Discussion of Maintenance Items 331 and 332

Revision 2

IEEE 802.1 TSN TG 2021.08.09

Introduction

Maintenance Item #331 - 17 (Example 1)

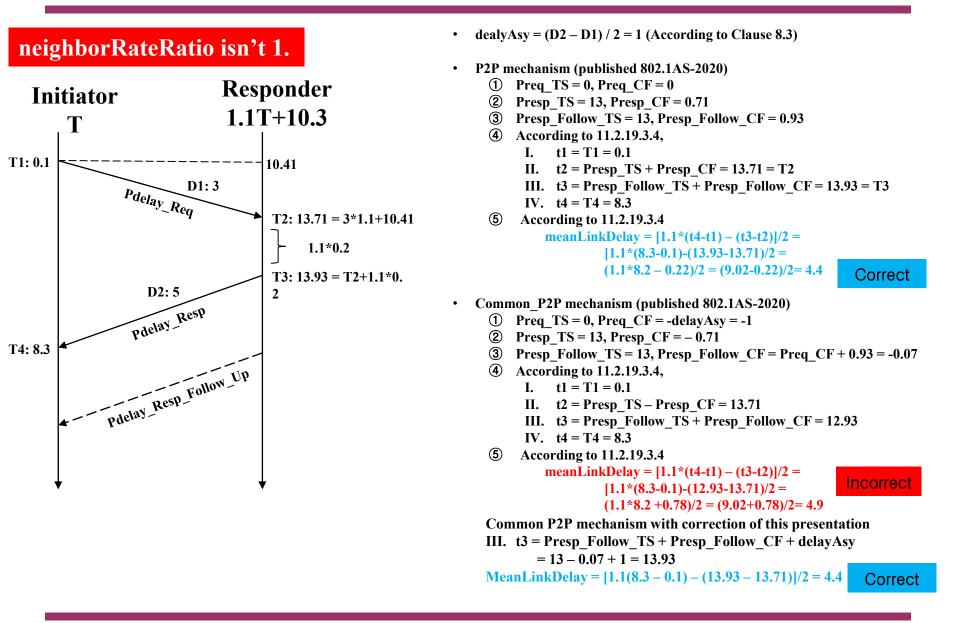
- delayAsy = (D2 D1) / 2 = 1 (According to Clause 8.3)
- P2P mechanism (published 802.1AS-2020)
 - (1) $Preq_TS = 0$, $Preq_CF = 0$ (item b of 11.2.17.2)
 - Presp_TS = 13, Presp_CF = 0.4 (item c of 11.2.17.2)
 - **③** Presp_Follow_TS = 13, Presp_Follow_CF = 0.6 (item d of 11.2.17.2)
 - **④** According to 11.2.19.3.4,
 - I. t1 = T1 = 0.1
 - II. $t2 = Presp_TS + Presp_CF = 13.4 = T2$
 - III. t3 = Presp_Follow_TS + Presp_Follow_CF = 13.6 = T3
 - IV. t4 = T4 = 8.3
 - (5) According to 11.2.19.3.4, MeanLinkDelay = [(t4-t1) - (t3-t2)]/2 = 4

- Common_P2P mechanism (published 802.1AS-2020)
 - ① $Preq_TS = 0$, $Preq_CF = -delayAsy = -1$ (item b of 11.2.17.2)
 - ② Presp_TS = 13, Presp_CF = -0.4 (item c of 11.2.17.2)
 - ③ Presp_Follow_TS = 13, Presp_Follow_CF = Preq_CF + 0.6 = -0.4 (item d of 11.2.17.2)
 - **(4)** According to 11.2.19.3.4,
 - I. t1 = T1 = 0.1
 - II. t2 = Presp TS Presp CF = 13.4 (item *e* of 11.2.17.2)
 - III. t3 = Presp_Follow_TS + Presp_Follow_CF = 12.6
 - IV. t4 = T4 = 8.3
 - (5) According to 11.2.19.3.4, MeanLinkDelay = [(t4-t1) - (t3-t2)]/2 = 4.5

Incorrect

Common P2P mechanism with correction of this presentation III. t3 = Presp_Follow_TS + Presp_Follow_CF + delayAsy = 13 - 0.4 + 1 = 13.6

MeanLinkDelay = [(8.3 - 0.1) - (13.6 - 13.4)]/2 = 4

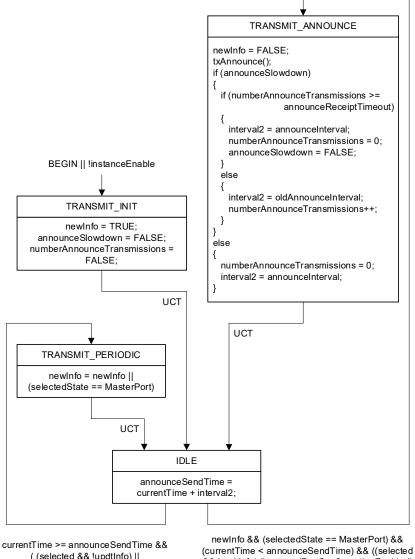
An Announce message is transmitted by the PortAnnounceTransmit state machine when the global variable newInfo is set to TRUE

□ From the IDLE state, if newInfo is TRUE and selectedState is MasterPort (and currentTime is not yet announceSendTime), the right branch is taken and an Announce message is sent

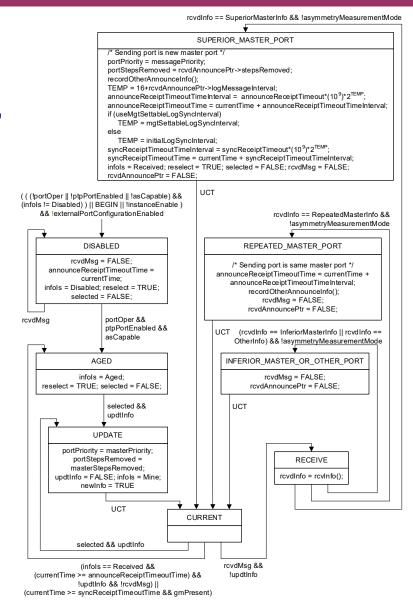
UpdtStatesTree() determines the port state in item f) of 10.3.13.2.4; in f)3), f)4), and f)8) of 10.3.13.2.4, the port state is set to MasterPort and the variable updtInfo is set to TRUE

- This in turn causes the PortAnnounceInformation state machine to transition from the CURRENT state to the UPDATE state, which in turn sets updtInfo to FALSE and newInfo to TRUE
 - As indicated two slides previously, this causes the PortAnnounceTransmit state machine to transmit an Announce message

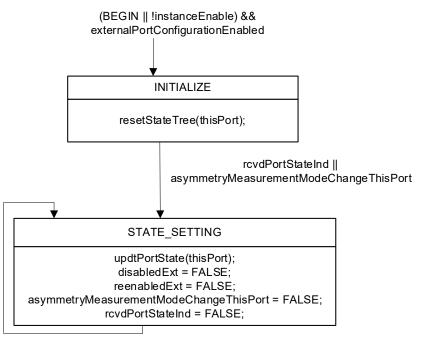
In the published 802.1AS-2020, when external port configuration is used newInfo is not set to TRUE, and an Announce message is not immediately sent

In external port configuration, the port state is set by the function updtPortState(thisPort) in the PortStateSettingExt state machine

The problem can be fixed by setting newInfo to TRUE in item c)3) of updtPortState(j), where the port state is set

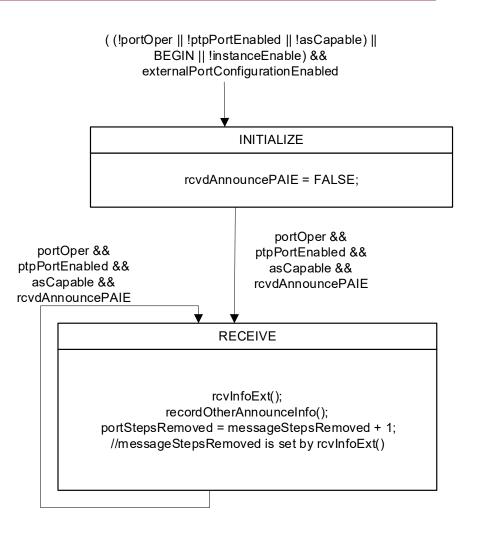
In external port configuration, the PortAnnounceInformation state machine is not invoked because the BMCA is not triggered by receipt of an Announce message

PortAnnounceInformationExt state machine is invoked, which simply records information contained in the Announce message (e.g., time properties information)

- □In addition, minor changes are needed for the overview diagram for External Port Configuation (Figure 10-12)
 - •The variable newInfo should be removed from the arrow going from the PortAnnounceInformationExt block to the PortAnnounceTransmit block
 - The variable newInfo should be added to the arrow going from the PortStateSetting block to the PortAnnounceTransmit block.

- Add the following sentence to item c)3)of the updtPortState(j) function (see 10.3.15.2.2): If portStateInd is equal to MasterPort, set newInfo to TRUE. Item c)3) then reads:
 - 3) selectedState[j] is set to portStateInd. If portStateInd is equal to MasterPort, set newInfo to TRUE.
- In Figure 10-12, remove the variable newInfo from the arrow going from the PortAnnounceInformationExt block to the PortAnnounceTransmit block (note that newInfo is not set by the PortAnnounceInformationExt block)
- □In Figure 10-12, add the variable newInfo to the arrow going from the PortStateSetting block to the PortAnnounceTransmit block
